City of Tucker

Land Use Petition: RZ-22-0001

Date of Staff Recommendation Preparation: April 7, 2022

| PROPOSED DEVELOPMENT: | Rezoning from R-75 to RSM to allow for the development of 52 townhomes. |

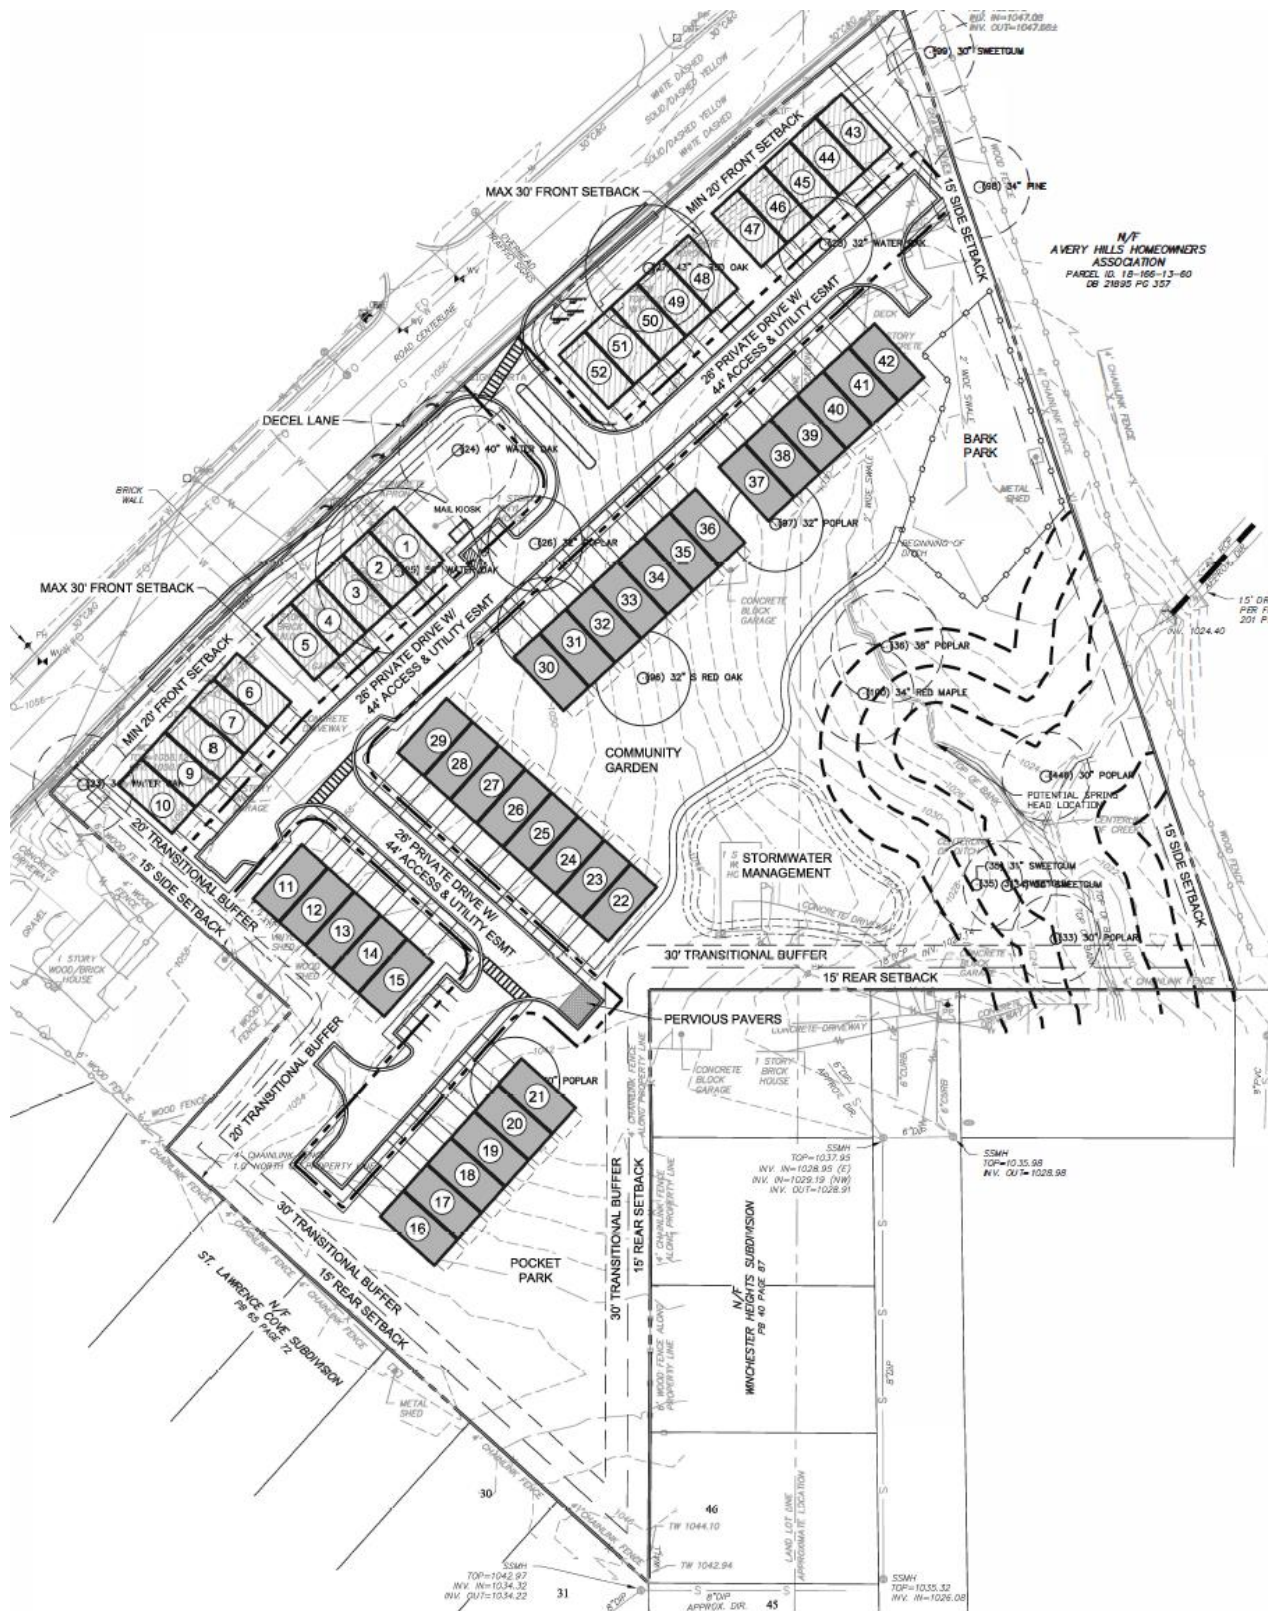
The applicant is requesting to rezone five parcels from R-75 (Residential Medium Lot – 75) to RSM (Small Lot Residential Mix) in order to construct a 52-unit single-family attached (townhome) development on approximately 8.7 acres, which will yield a density of 5.9 units per acre. Twenty (20) rear-loaded units are shown fronting Lawrenceville Highway and the remaining thirty-two (32) units are front-loaded and spread throughout the site. The townhome blocks range from five units to eight units.

The maximum height allowed within the RSM zoning district is 45' or 3 stories, whichever is less. While exact heights of the proposed townhomes were not submitted with the application, the applicant has stated the townhomes will comply with the City's requirements. From submitted elevations, the proposed townhomes appear to be 3 stories and will be constructed of a mixture of brick, board and batten, and shake, in a neutral palate.

Access is shown via one full-access drive from Lawrenceville Highway, that would line up with Terri Lynn Court when constructed. There are 13 guest parking spaces throughout the site, with three adjacent to the proposed mail kiosk. DeKalb Fire will require the townhome units to be sprinkled since only one vehicle access point is provided.

The site plan also shows a transitional buffer along the eastern, western, and southern sides of the development. Transitional buffers in residential neighborhoods are intended to diminish the potential negative impacts of higher intensity residential development on adjacent single-family residential land uses. The applicant has proposed a 30' transitional buffer along the southern and a majority of the western property lines, which exceeds the City's 20' transitional buffer requirement for the RSM zoning district.

While only 20% of the site is required to be reserved for open space, the submitted site plan shows several open space areas, totaling 4.5 acres (52% of the site), including a pocket park, in the southern portion of the property, adjacent to the St. Lawrence Cove subdivision and residential dwellings along Bishop Drive; a community garden, central to the development; and a bark park, along the eastern property line, north of the stream on the property. The submitted site plan shows full compliance with the dimensional requirements of the RSM zoning district.

The applicant could do more with regards to the goal of managing massing, by taking into consideration the smaller footprints and total square footage of existing housing stock. This could be achieved with a mix of product types, specifically within the southwest corner of the development where it abuts both St. Lawrence Cove and Bishop Drive residences.

- Based on the proposed site plan, because there are more than 30 units on a single access road, there would need to be a second access point for fire apparatus access.
- Alternatively, each unit shall be equipped with an approved fire sprinkler system per International Fire Code Appendix D Section D107.

- LDP will be required, including landscape plans, tree density calculations, and a hydrology report.
- Detention will need to be vetted as it is unclear if the proposed underground detention will be tied to the existing system.
- Compliance with private roads meeting DeKalb Fire standards will be required.

1. Use of the subject property shall be limited to up to a 52-unit townhome development.
2. The property shall be developed in general conformance with the site plan submitted on March 28, 2022 to the Planning and Zoning Department, with revisions to meet these conditions.

9. The side elevations of units 1, 5, 6, 10, 43, 47, 48, and 52 shall be clad in the primary building material of the front façades and designed with windows and other architectural features in order to provide a consistent design appearance along Lawrenceville Highway.

17. The detention pond shall be located on a separate lot of record.
18. The development shall be limited to a single full-access curb cut on Lawrenceville Highway. The location of said curb cut should align with Terri Lynn Court, is dependent on sight distance, and subject to the approval of the Tucker City Engineer and the Georgia Department of Transportation.
